CITY OF DOVER

PLANNING TECHNICAL REVIEW COMMITTEE –AGENDA

PLAN SNAPSHOT REPORT SITE-2024-0003 FOR CITY OF DOVER, N.H.

Plan Type: Site Plan - Major
Work Class: New Construction
Status: Fees Due
Valuation: \$0.00
Description: Multi-Unit Building with 4 two bedroom units, improved driveway access, parking, utilities and drainage improvements.

UTILITY PLAN		NOT FOR CONSTRUCTION FOR PERMIT USE ONLY									
8	LOCUST STREET RESIDENTIAL DEVELOPMENT DOVER, NH	17-19 SUMMER STREET PROPERTIES, LLC 71 LAFAYETTE ROAD HAMPTON FALLS, NH 03844

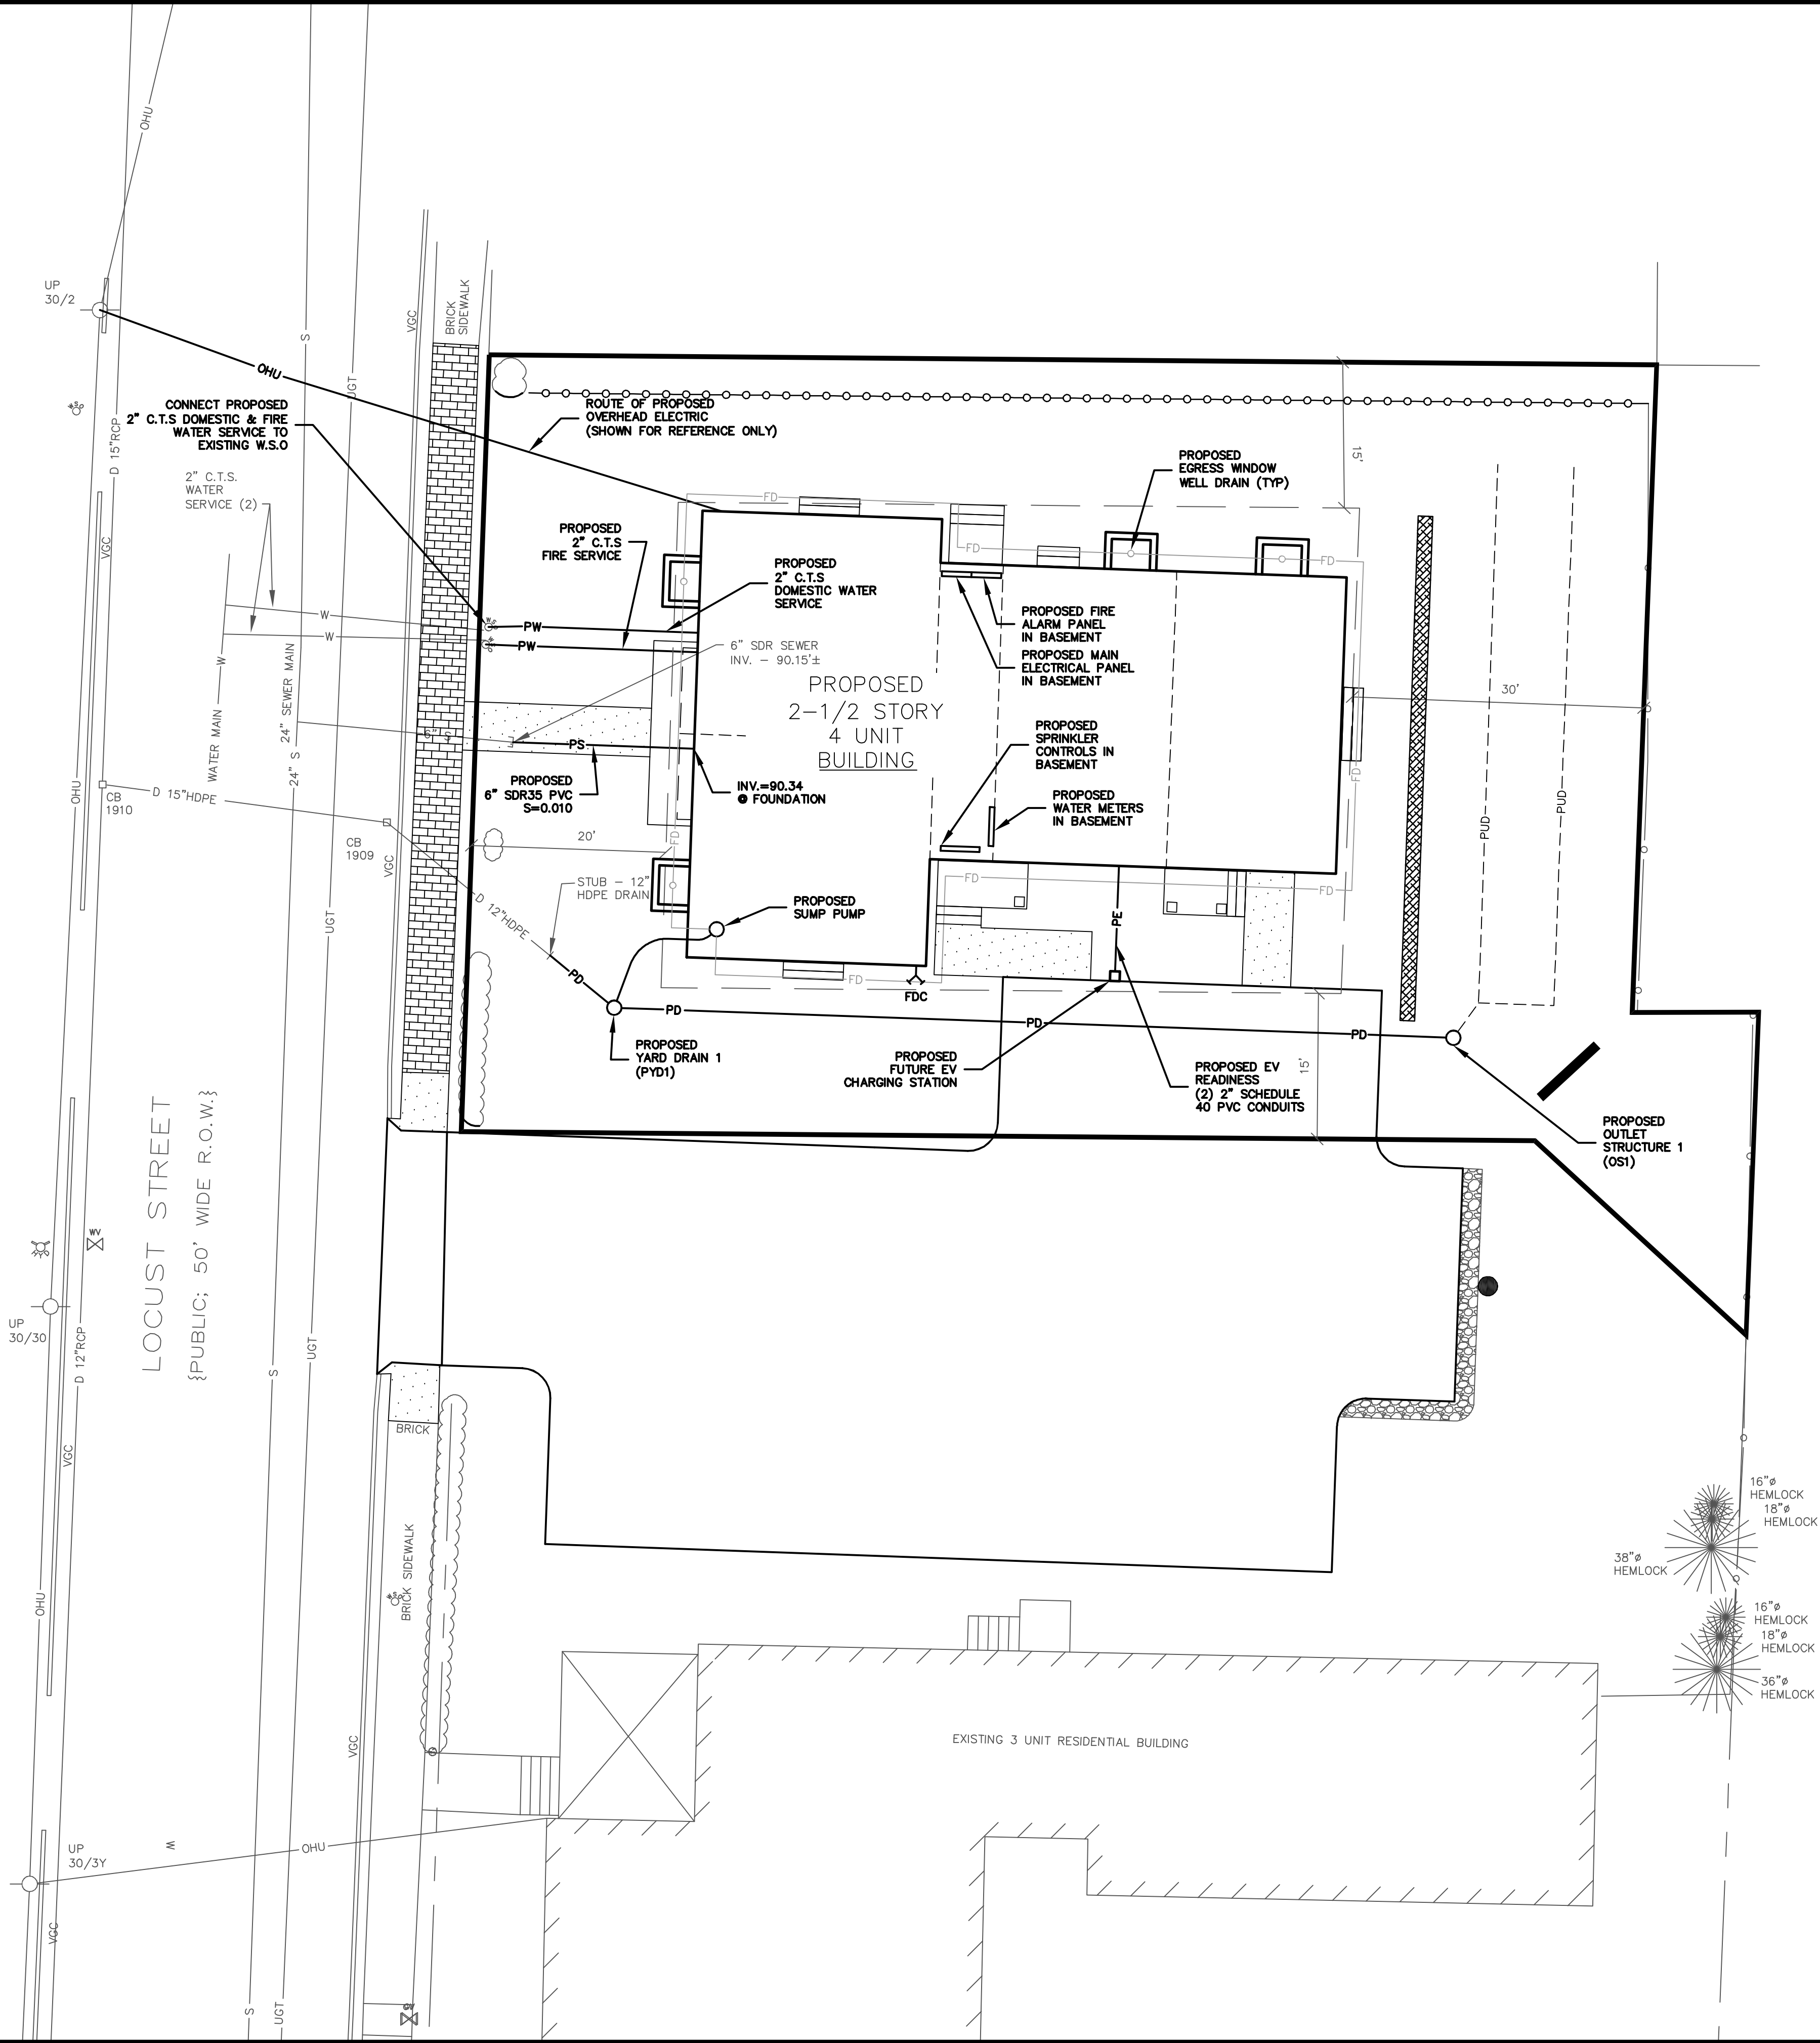
- Sheet 8:

- Sheet 7:
 - Show inverts for all proposed structure on the plan not just the detail sheet.
- Sheet 8:
 - CTS may be used from the curb stop to the building for water services.

- Will the building have submeters monitored by the Applicant? As proposed the building will receive one meter from the City.
- Sheet 12:
 - The driveway apron should be paved and is the responsibility of the property owner not the City.

The location of the water meters has been added to the plan set.

LIGHTING PLAN

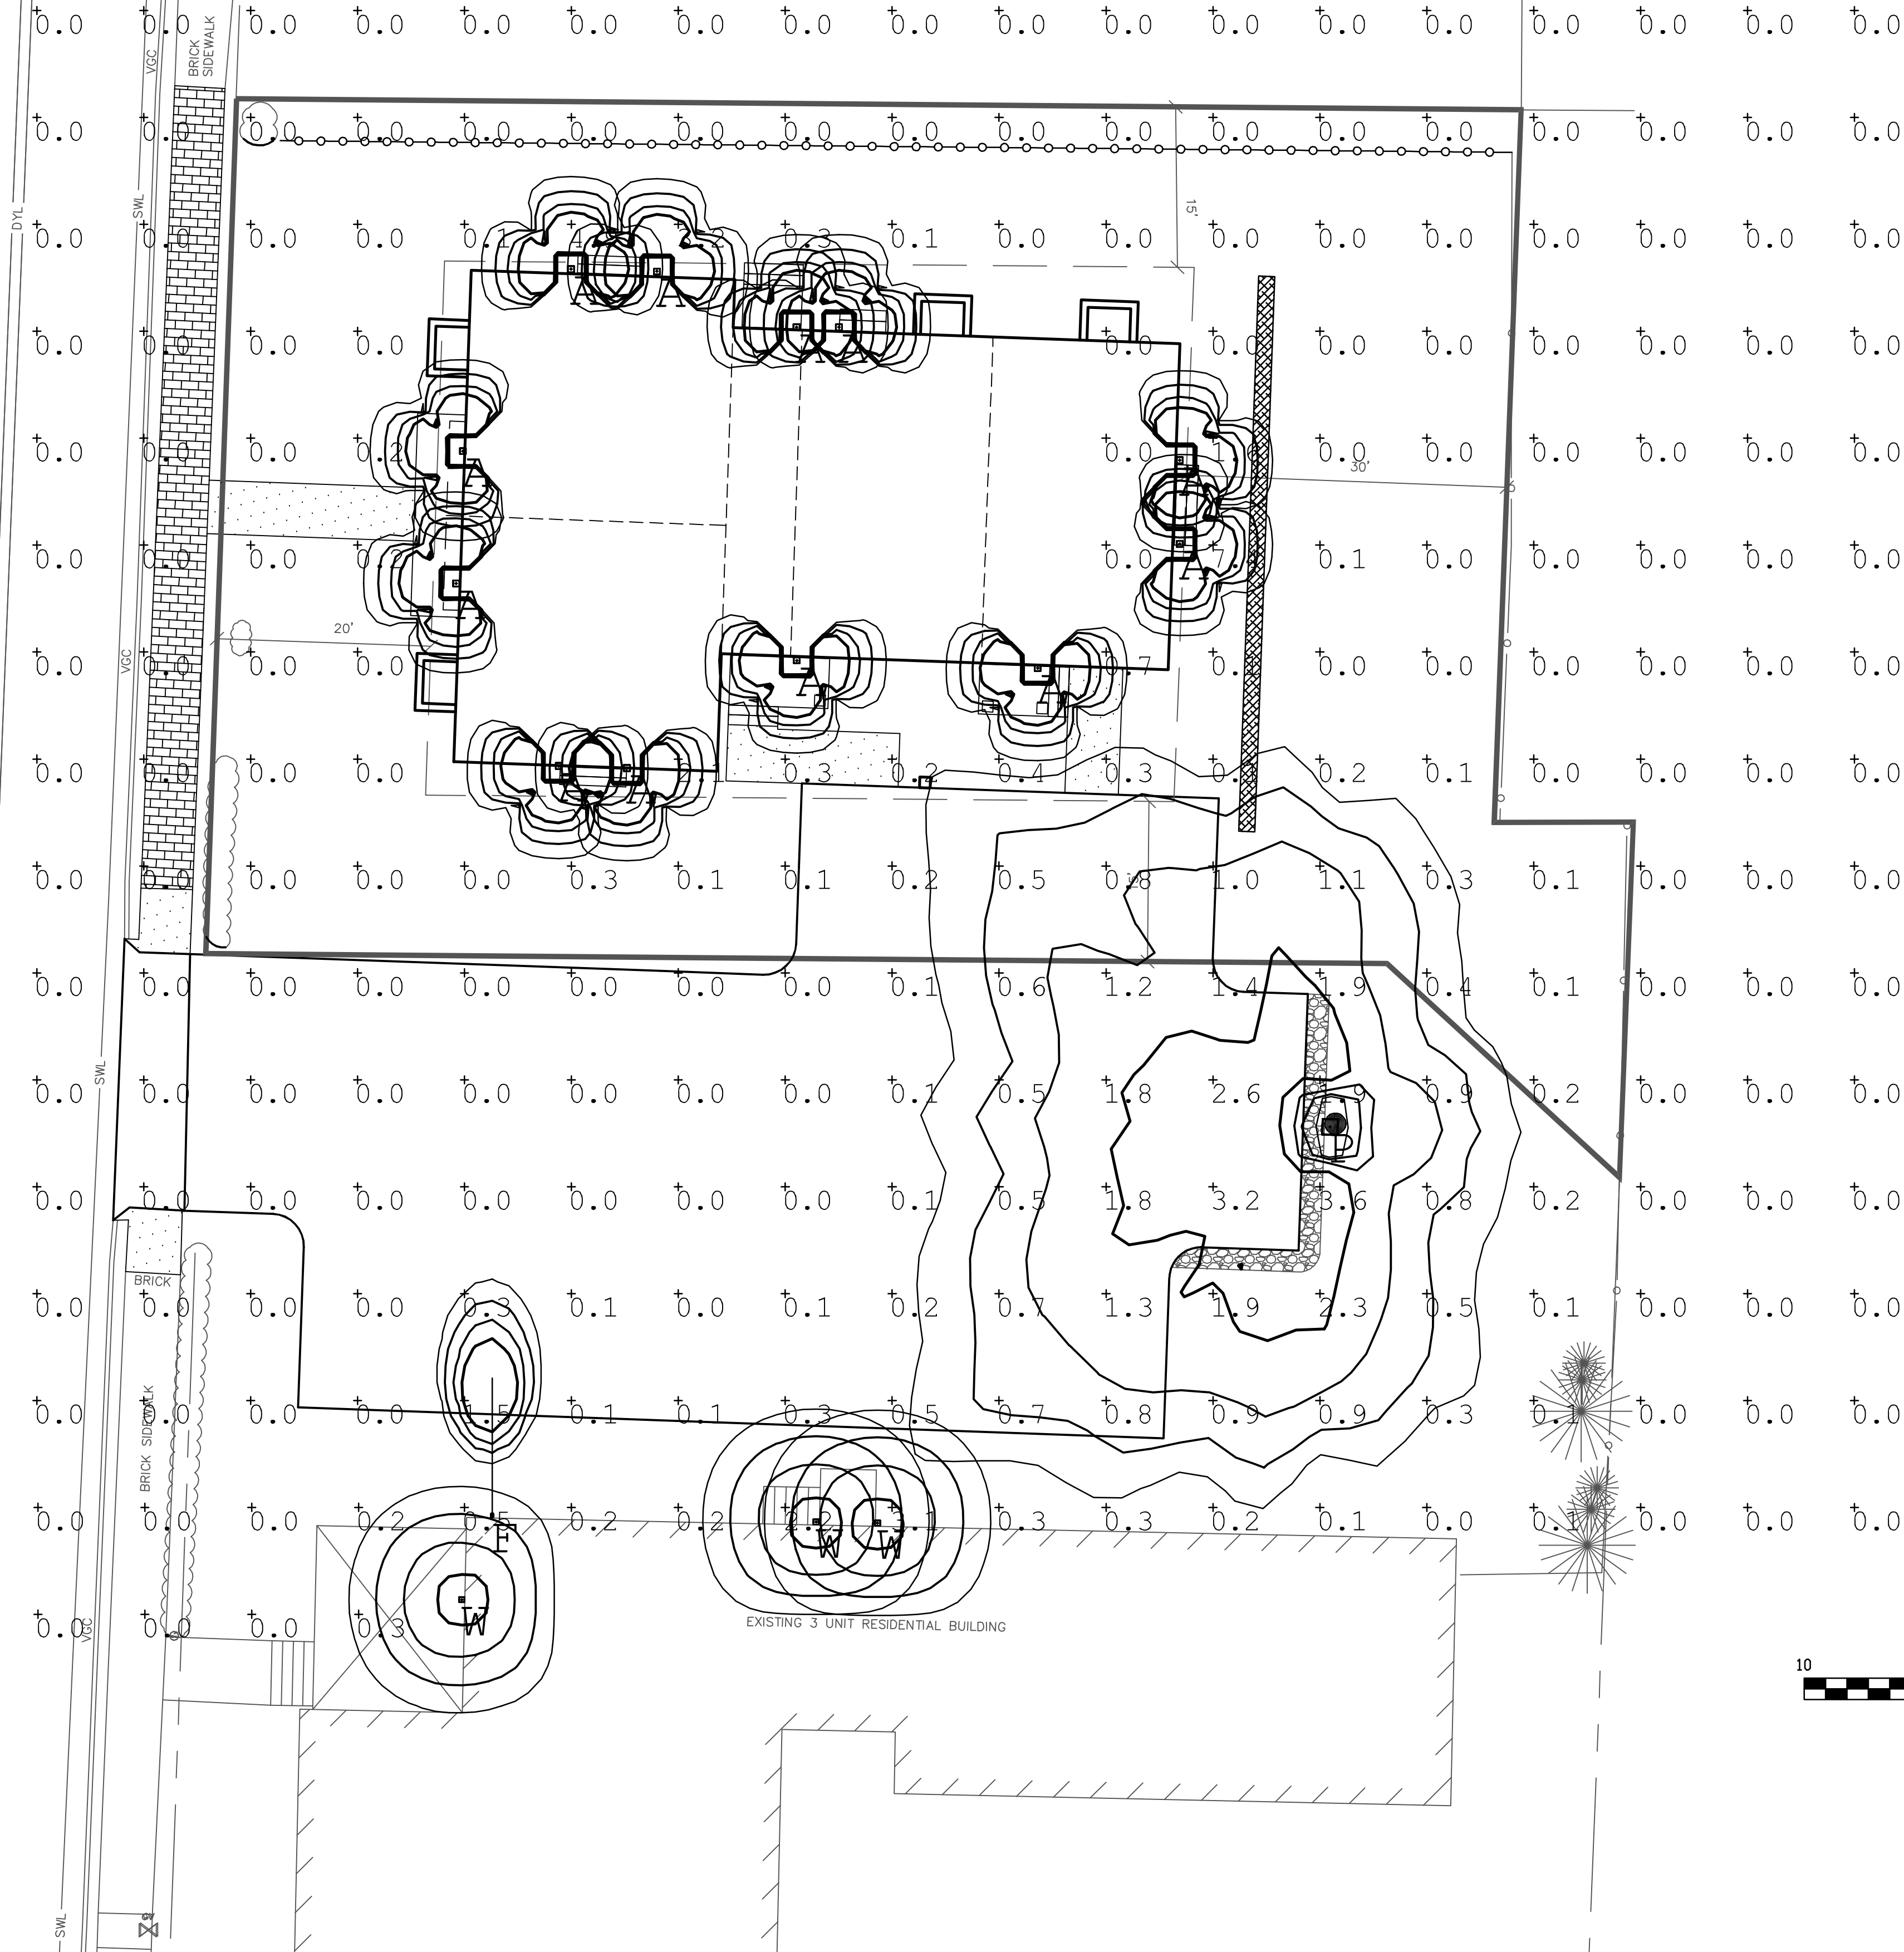
- Sheet 16:

● Sheet 16:

The lighting plan has been updated to include the existing and proposed lighting associated with the two buildings.
